# Drinking Water Audit Report

| <b>Plant(s) visited:</b> | Galtee Regional Water Treatment Plant  | <b>Date of issue of Audit Report:</b> | 24 <sup>th</sup> November 2015         |
|                          |  | <b>File Reference:</b>                | DW2015/156                             |

Photograph 1: Floc on surface of water in clarifier

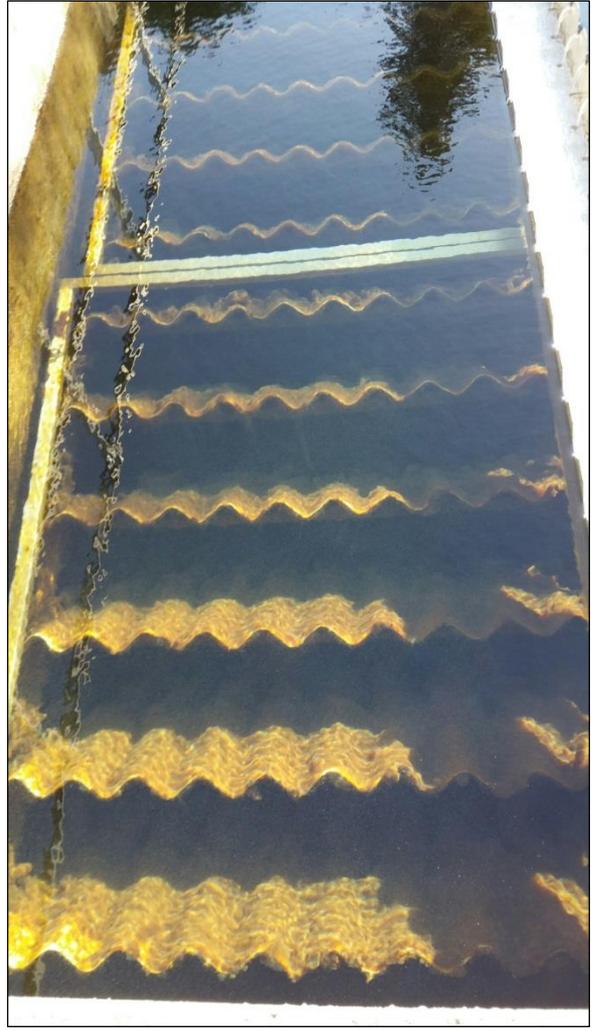
The Galtee Regional water treatment plant was found to be extremely well managed by highly competent and dedicated staff. Considerable efforts have been made to investigate and address the issue of aluminium exceedances at the water treatment plant following heavy rainfall events that typically bring highly coloured and turbid water to the plant. Actions to address the issue were discussed between Irish Water, Tipperary County Council and the EPA during the audit and include; installation of automatic shut off valves on the raw water sources or a raw water balancing tank to enable the plant to avoid or deal more effectively with highly coloured and turbid water, installation of a new static mixer and flocculation tank at the water treatment plant to improve the contact time of coagulant dosed on the raw water and further investigation into optimisation of the clarification process. These actions are included in the Recommendations section of this audit report.

3. Irish Water should review the coagulant mixing process to ensure that there is adequate mixing and contact time of the coagulant prior to entry into the clarifier. Irish Water should implement the following actions as discussed during the audit;
  - i. Install a new static mixer after coagulant dosing; and
  - ii. Install a flocculation tank at the water treatment plant.
4. Irish Water should review the operation of the clarifiers to ensure that they are operating as effectively as possible and producing a stable floc blanket. The following items should be reviewed;
  - i. The installation of a cover on the clarifiers to reduce wind interference; and

- ii. The use of the retro-fitted lamellae plates in the clarifiers.
